## Applicable Urban Design Priorities Project Should Achieve

## Alamo Drafthouse - Lake Highlands

Neighborhood:  
Lake Highlands

*Skillman Corridor TIF District*

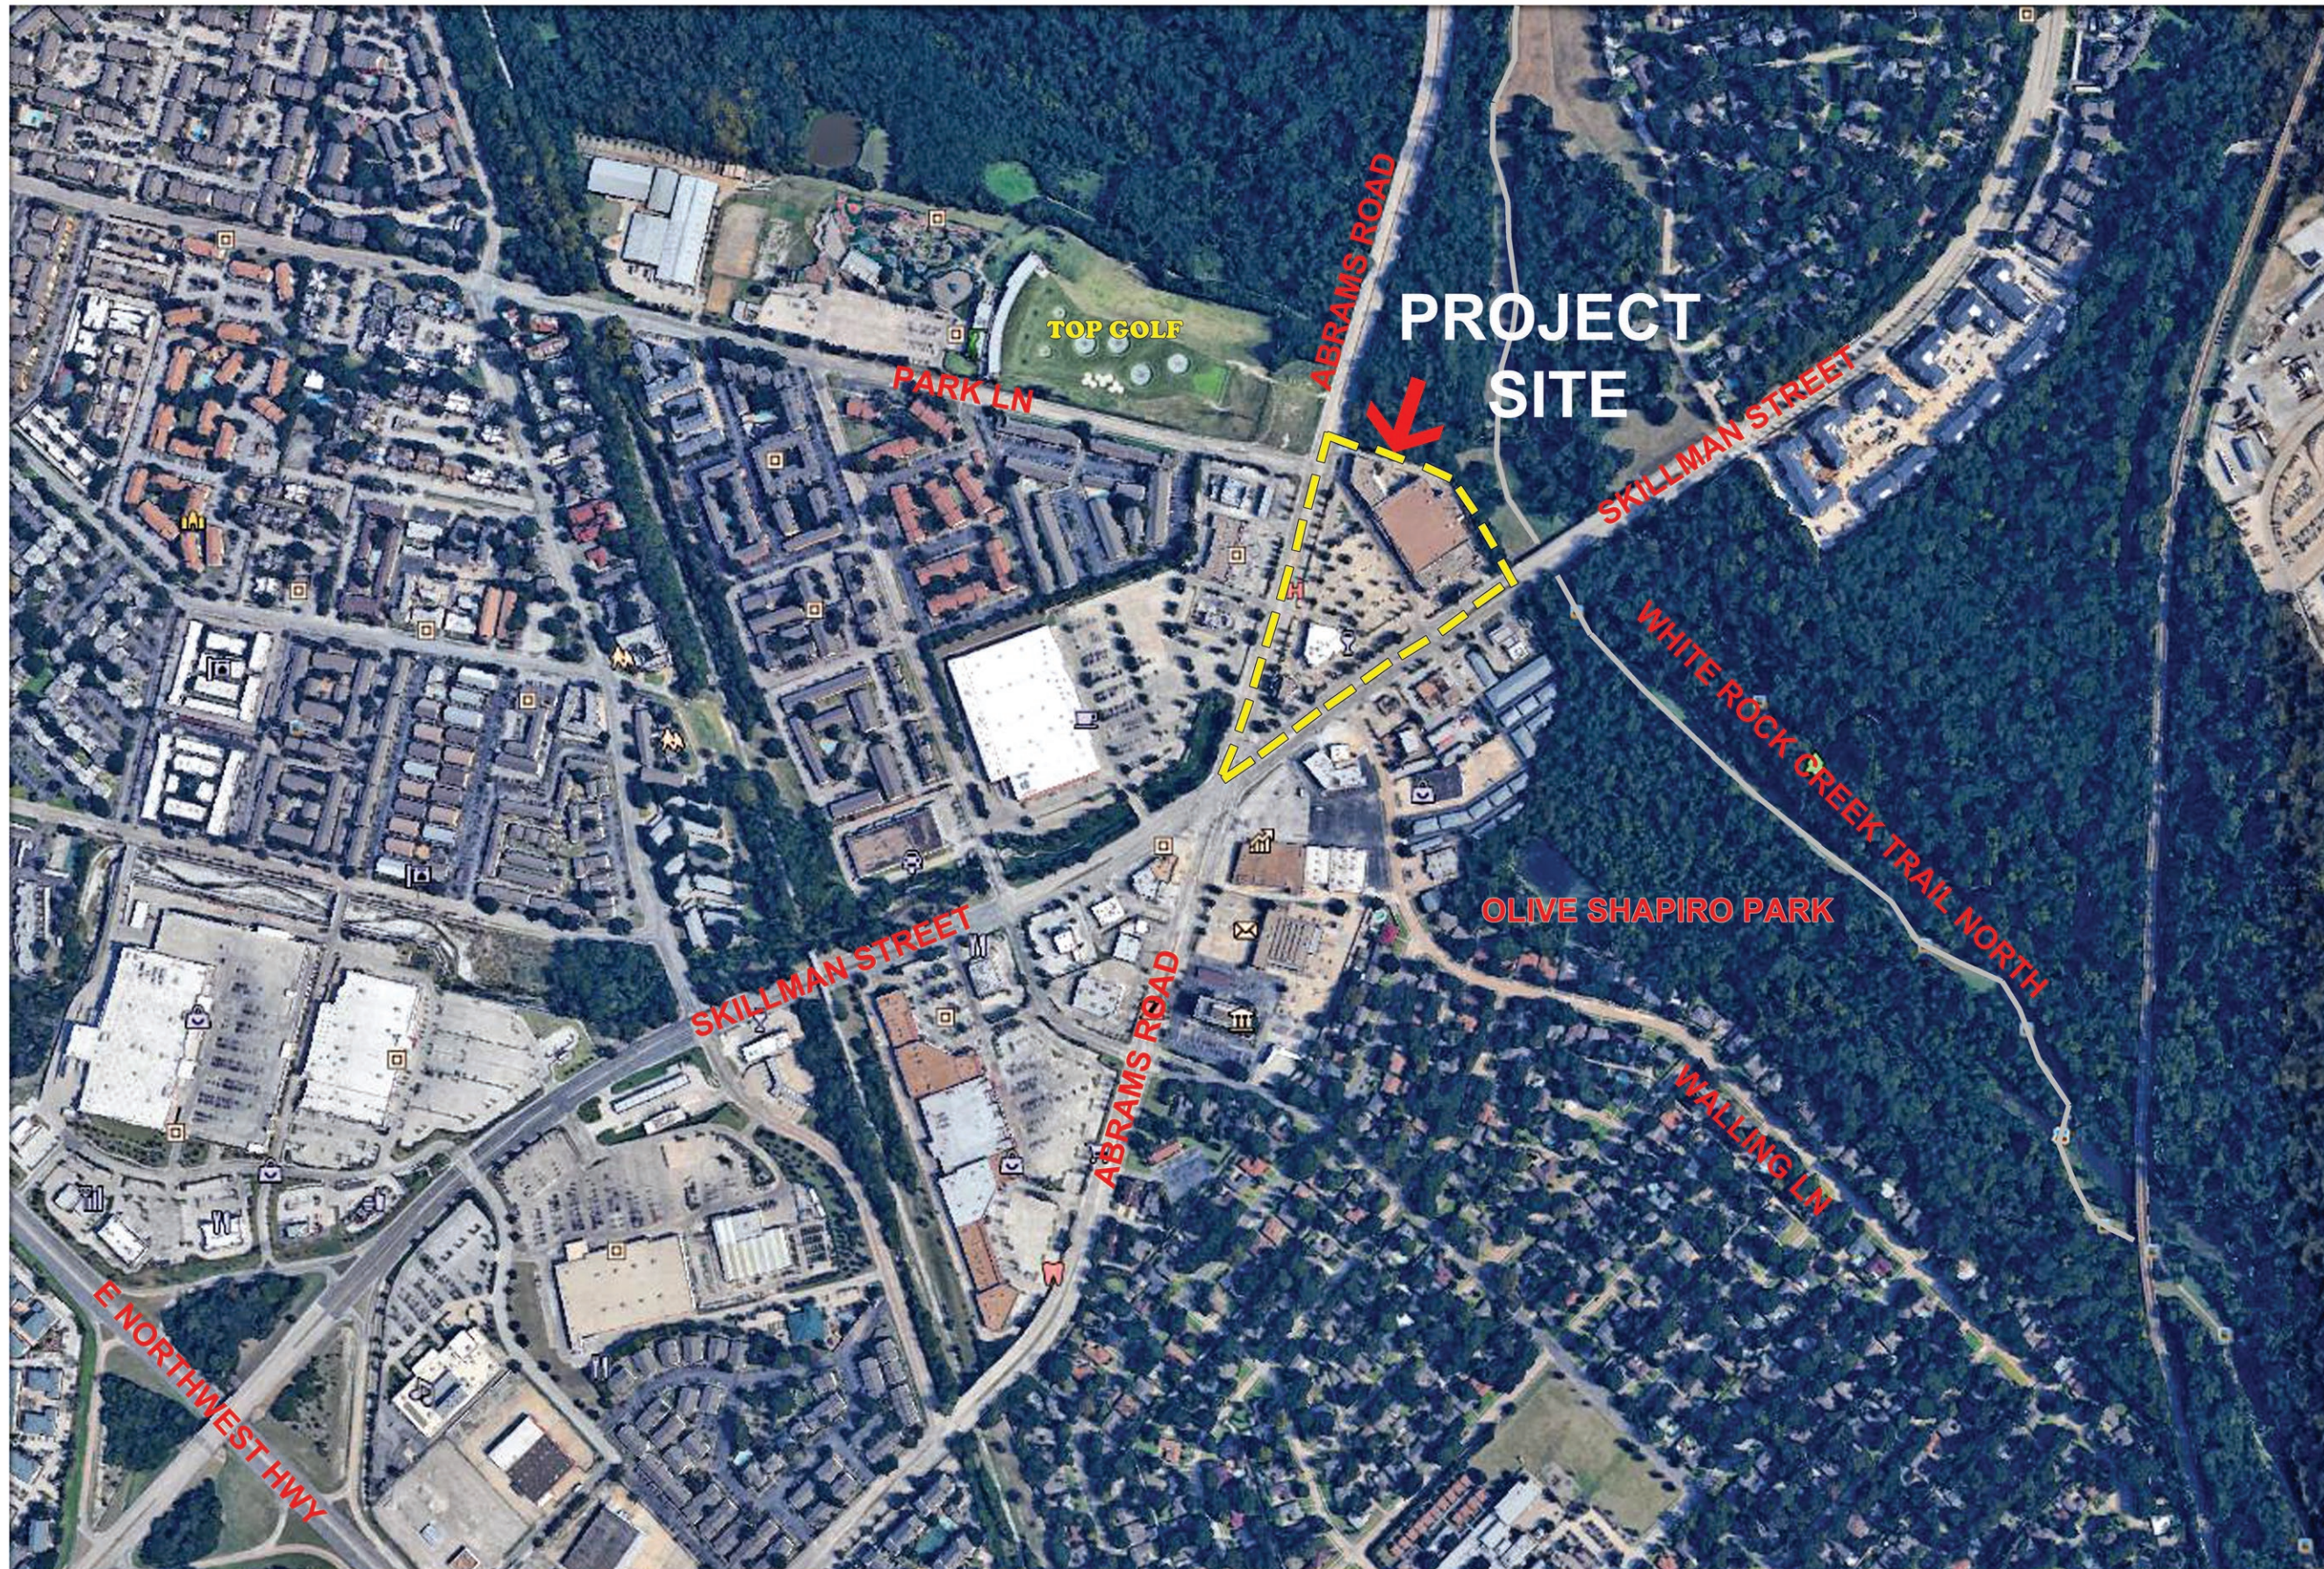
### [1] Consider creation of a connection to White Rock Creek Trail

As this development sits at the nexus of planned bike facilities along Park Ln. and the existing White Rock Creek Trail, this development has the opportunity to be a critical link to the White Rock Creek Trail. Additionally, with the trail and bike facilities in mind, the development should consider additional bike parking and other amenities.

### [2] Improve intersection at Park Ln. and Abrams Rd. to facilitate bike and pedestrian movement to proposed White Rock Creek Trail connection.

With dedicated bike lanes planned along Park Ln., improvements to the Park Lane/ Abrams Road intersection are important to create safer bike and pedestrian movements to the site and continuing on to the White Rock Creek Trail

### [3] Enhance pedestrian realm along Abrams Rd. and Skillman St.

Improvements to the pedestrian realm conditions along Abrams Rd. and Skillman St. are important to ensure accessible and safe access to the site and facilitate pedestrian and bicycle connectivity to and from movie theater and the White Rock Creek Trail.

Primary considerations for the project include improvements to the pedestrian realm around the site, enhancements to the signalized intersection at Abrams and Park Lane to connect dedicated bike lanes planned for Park lane to the site, and the creation of a new connection to the adjacent White Rock Creek Trail.
